**BROOKLYN 1B**  
1309 NE 66TH ST

DESIGN REVIEW RECOMMENDATION  
25 JUNE 2018  
DPD #3026788

ADDRESS: 1309 NE 66TH ST  
PROJECT #: 3026788

PROPOSED DRIVEWAY SECTION

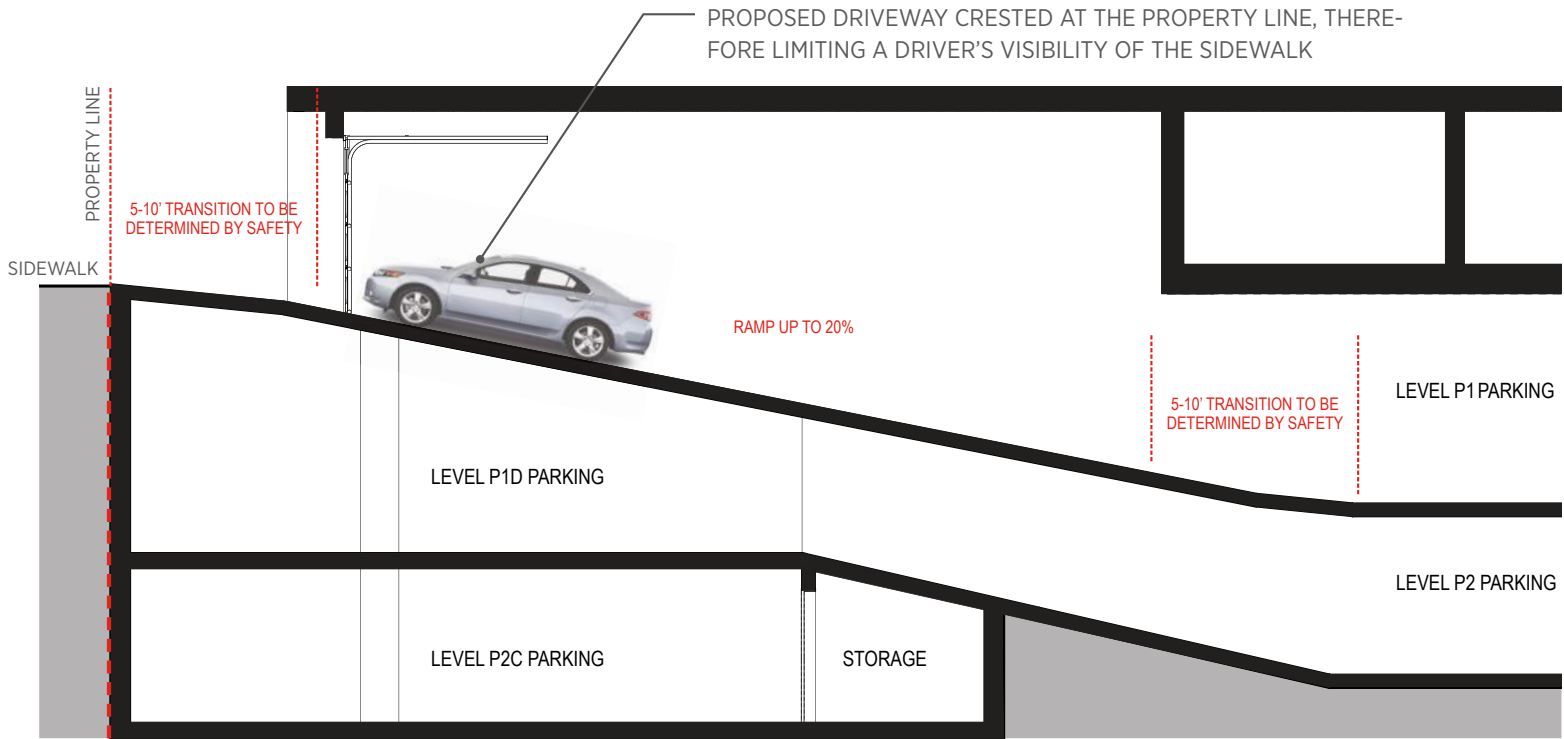
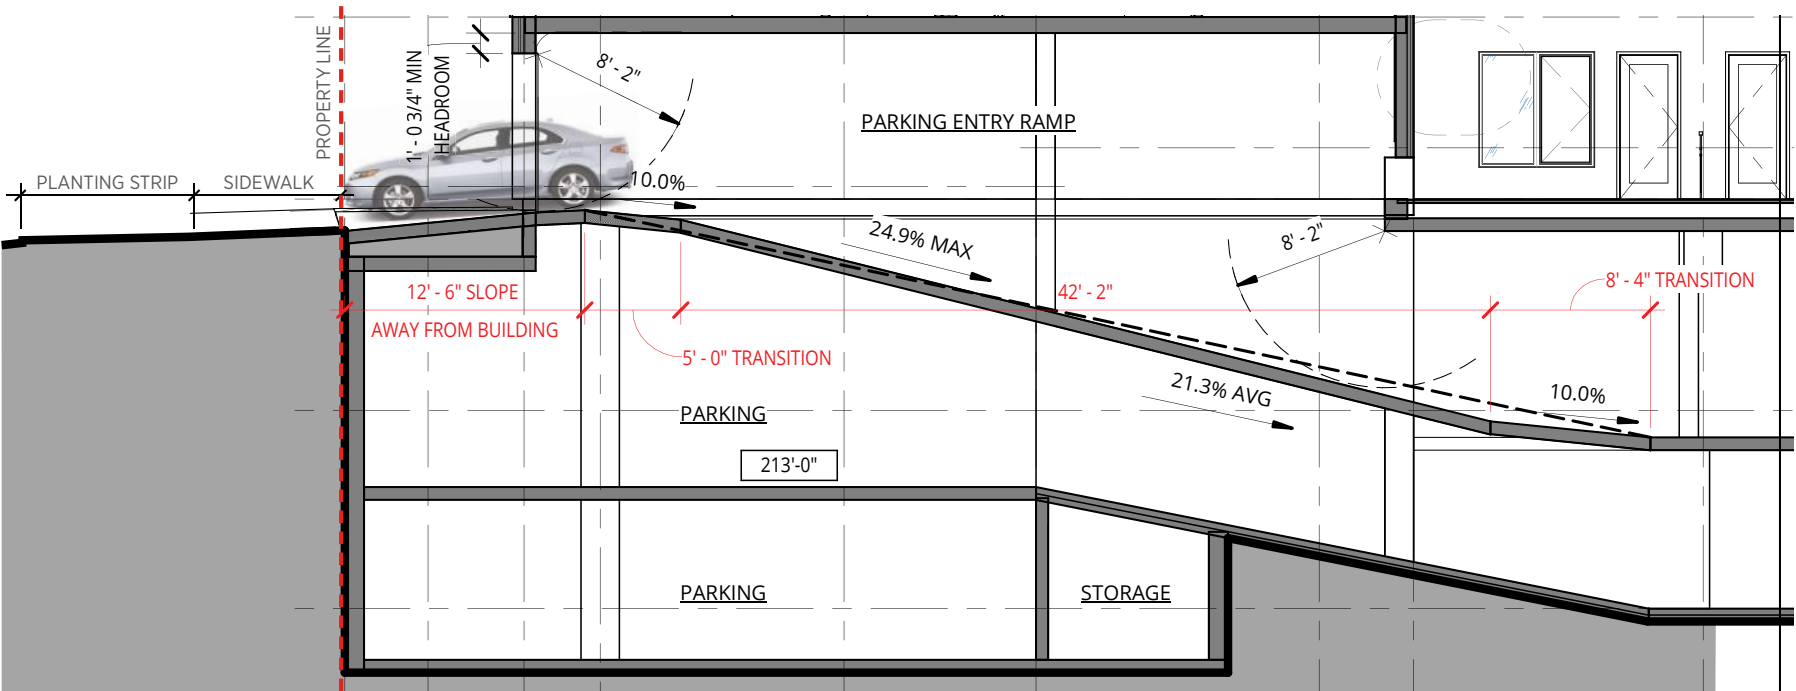
The Board indicated preliminary support of the Director approving the decision to approve this departure request although some Board members concerns about safety at the top of the ramp and wanted to see better documentation as to how and why the departure works.

Permit a driveway slope of up a maximum of 25%.

Proposed ramp slope is increased from “up to 20%” in the EDG proposal with a transition crest at the sidewalk grade to an average of 21.3% with a flat approach at grade between the sidewalk and garage door to increase pedestrian safety.
